HISTORIC PRESERVATION COMMISSION

SUBJECT: Historic Area Work Permit #450829, tree removal and replacement and driveway removal

HISTORIC PRESERVATION COMMISSION STAFF REPORT

| PROPOSAL: | Tree removal and replacement, driveway alterations, and gate installation | | |

PLANTING PLAN

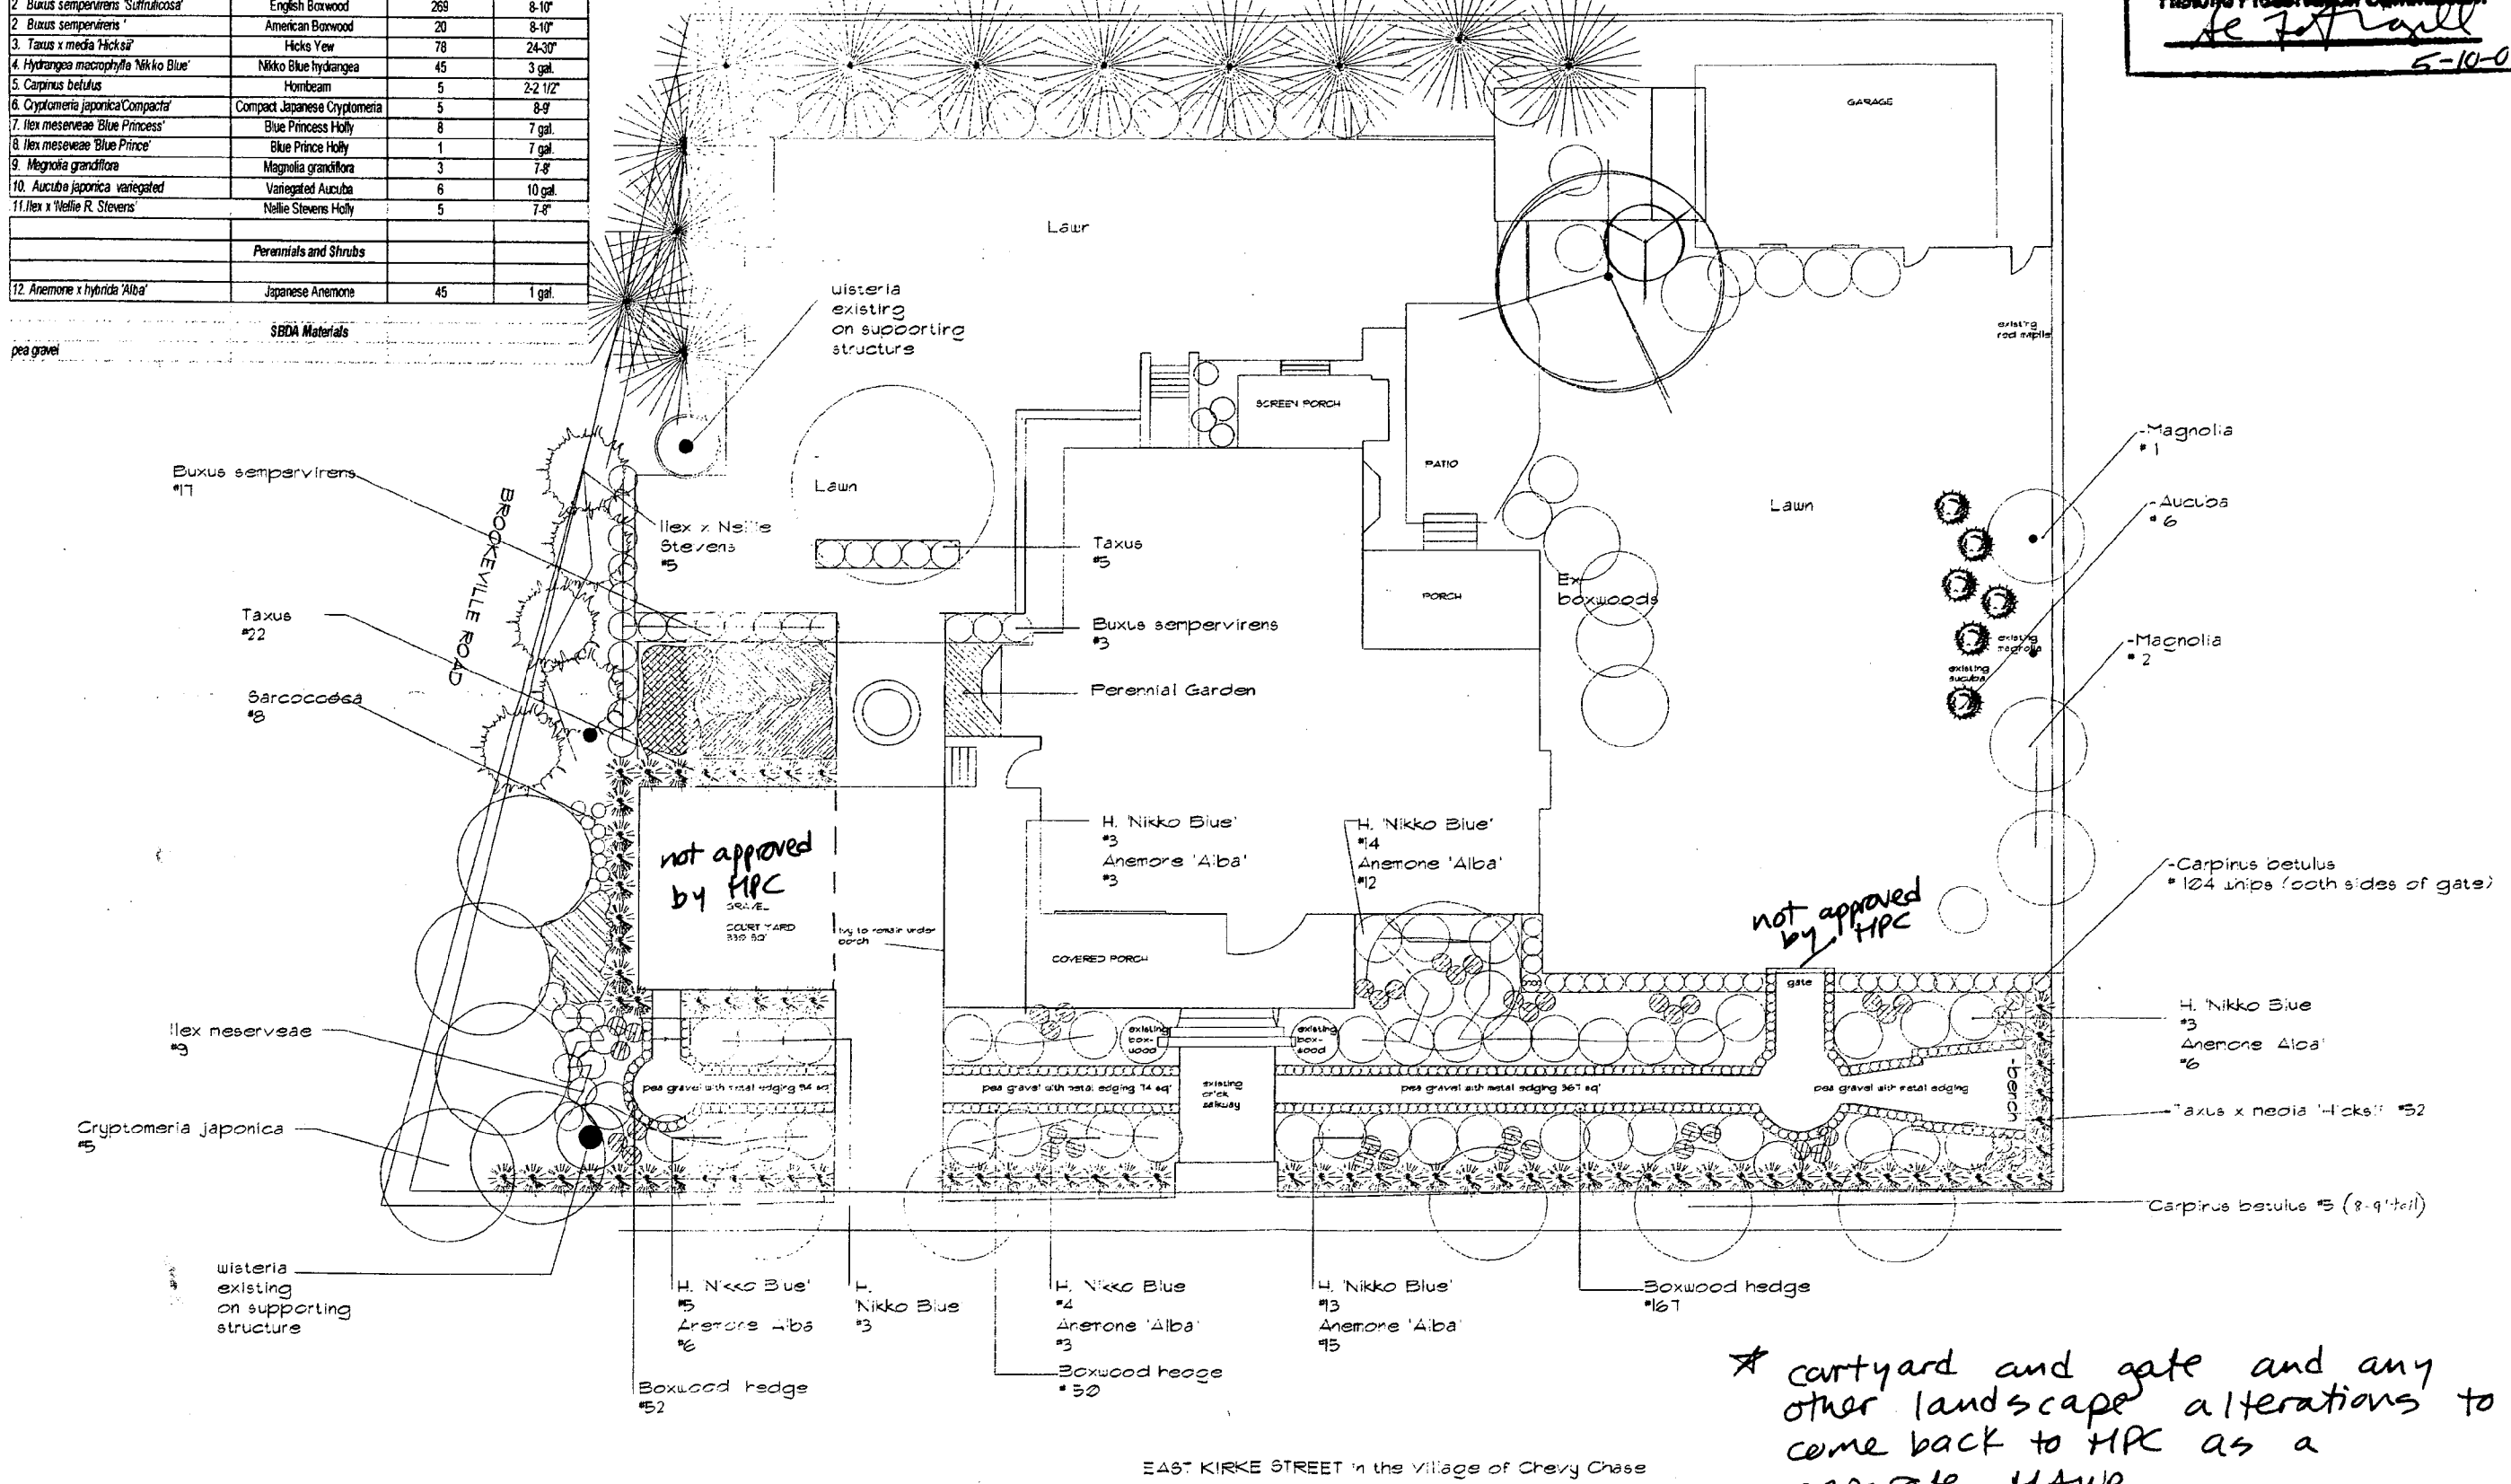
tree removal and replacement, pea gravel paths, and driveway reduction approved by HPC. *

* courtyard and gate and any other landscape alterations to come back to HPC as a separate HAWP

tree removal and replacement, pea gravel paths, and driveway reduction approved by MPC.*

* courtyard and gate and any other landscape alterations to come back to MPC as a separate HAWP

1. A landscape plan showing the left side terrace and right side gate will be submitted as a separate HAWP application for HPC approval.

SITE ANALYSIS

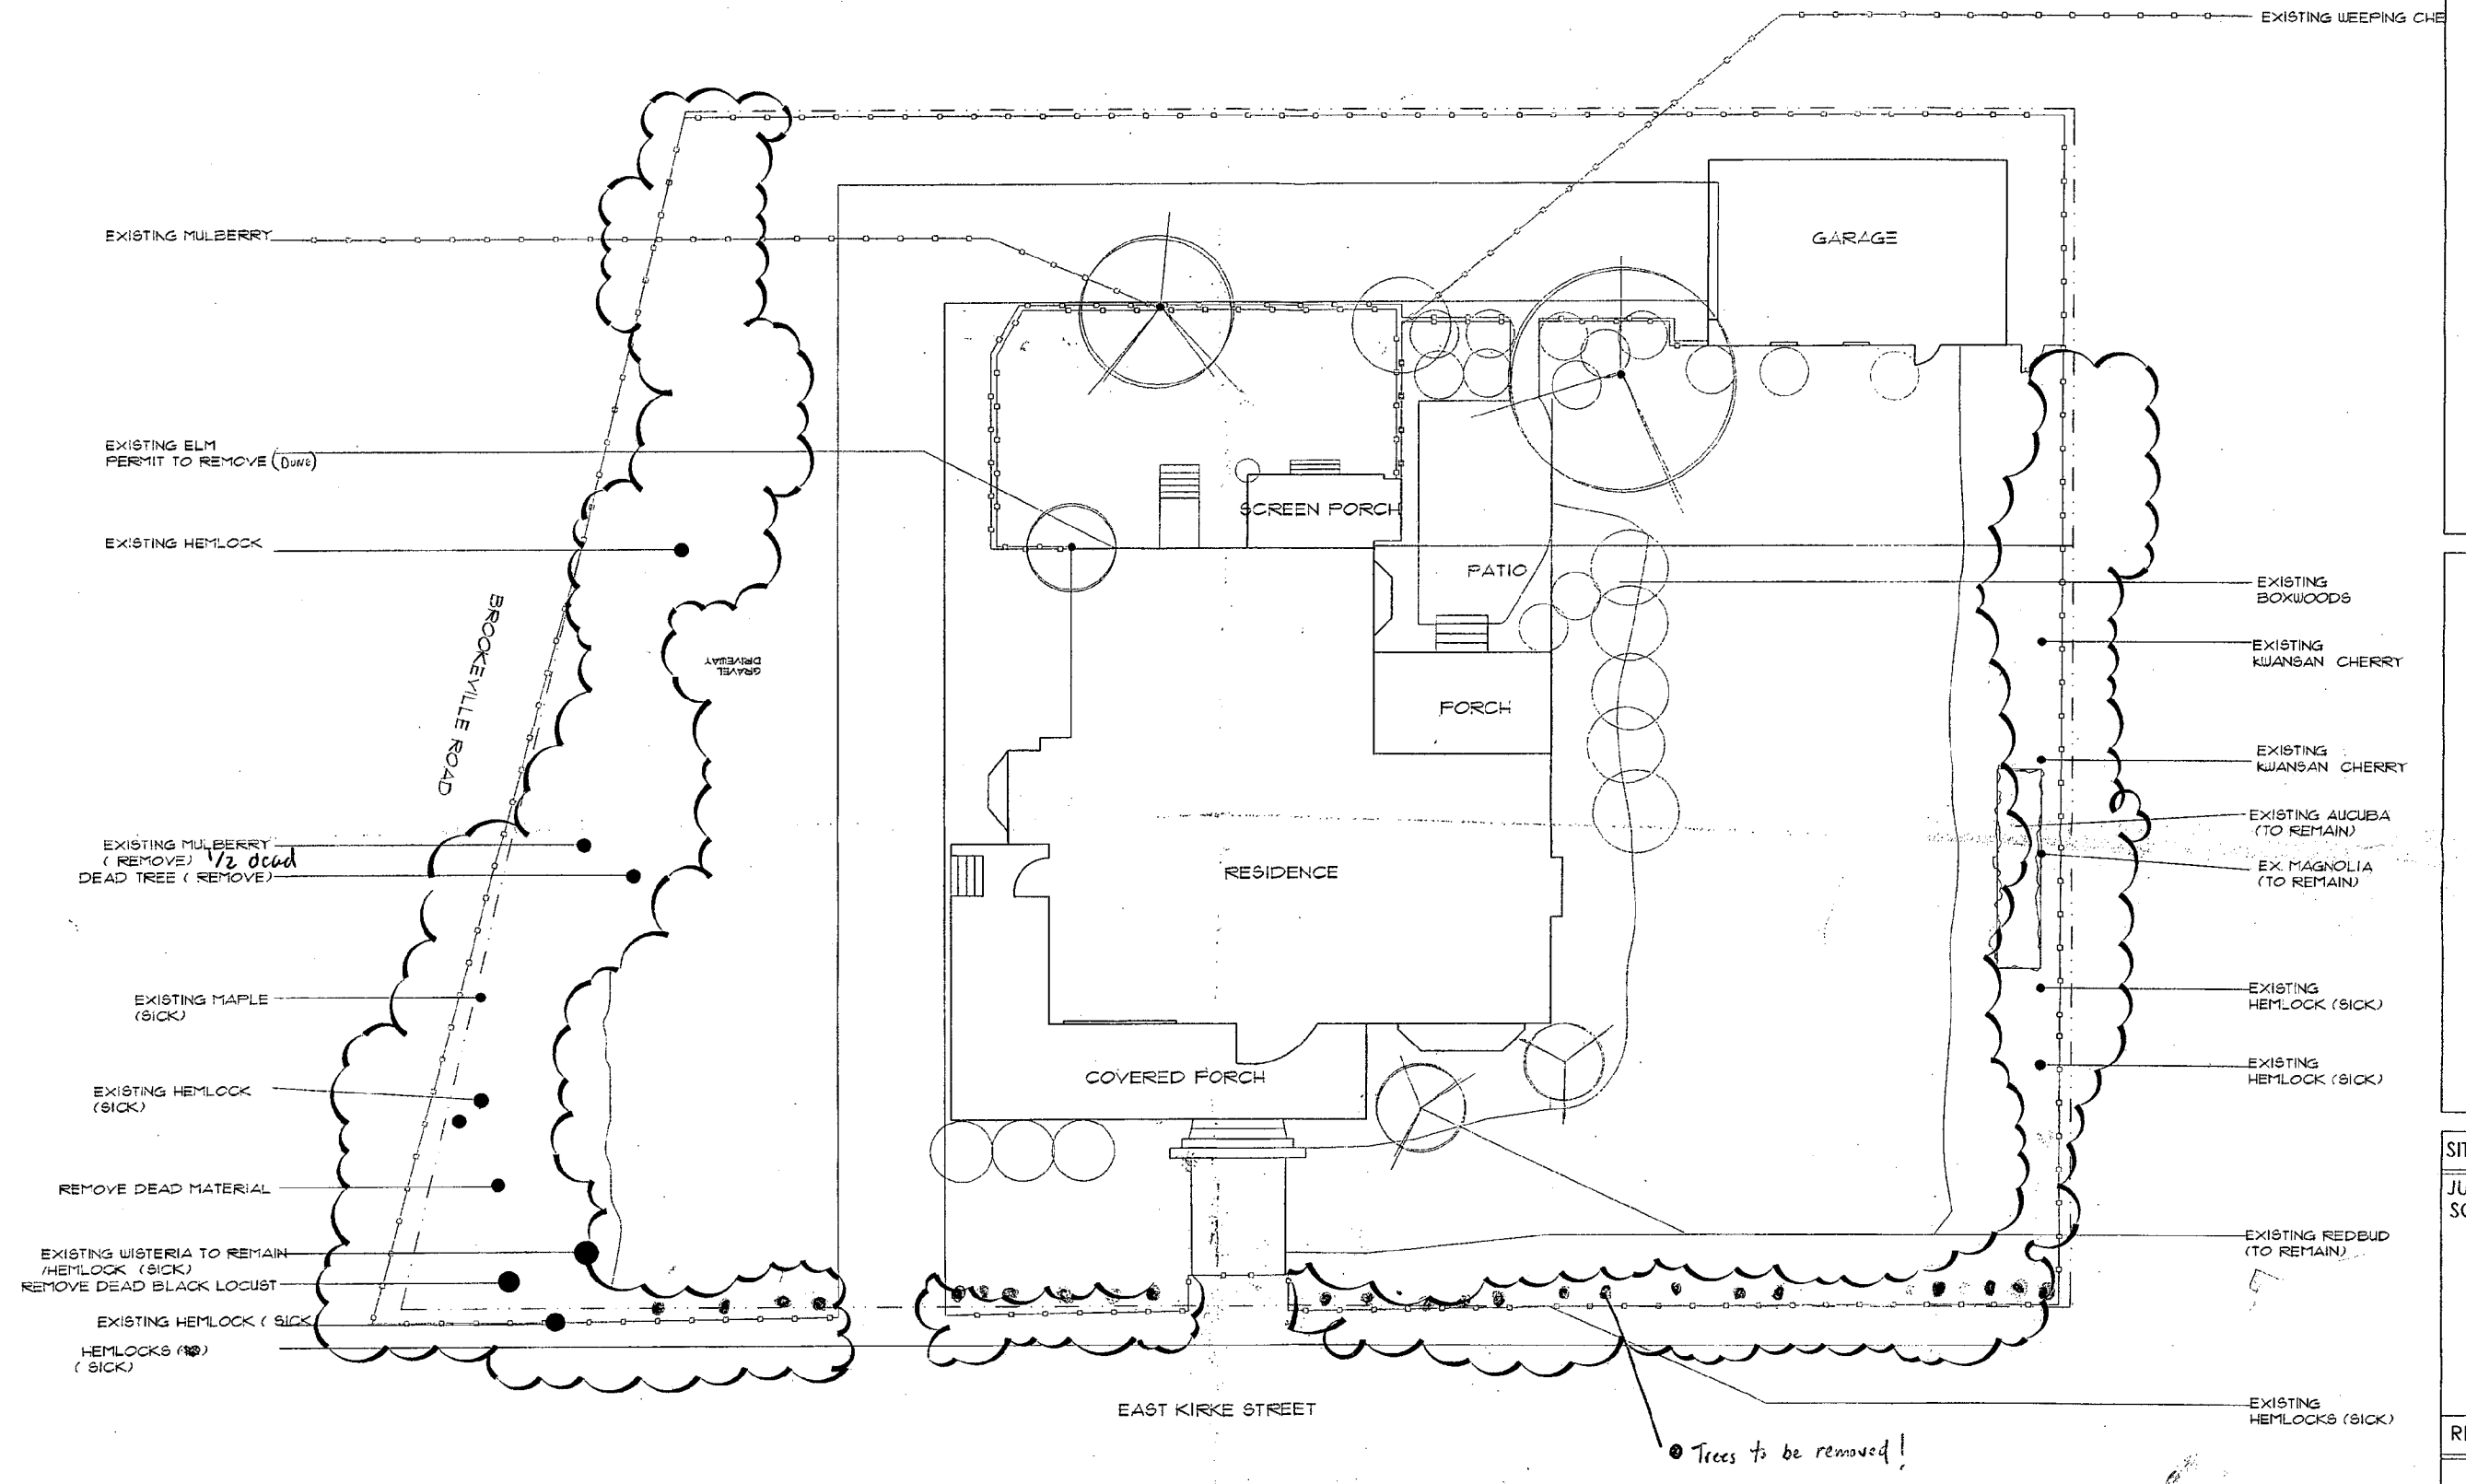
Trees to be removed!
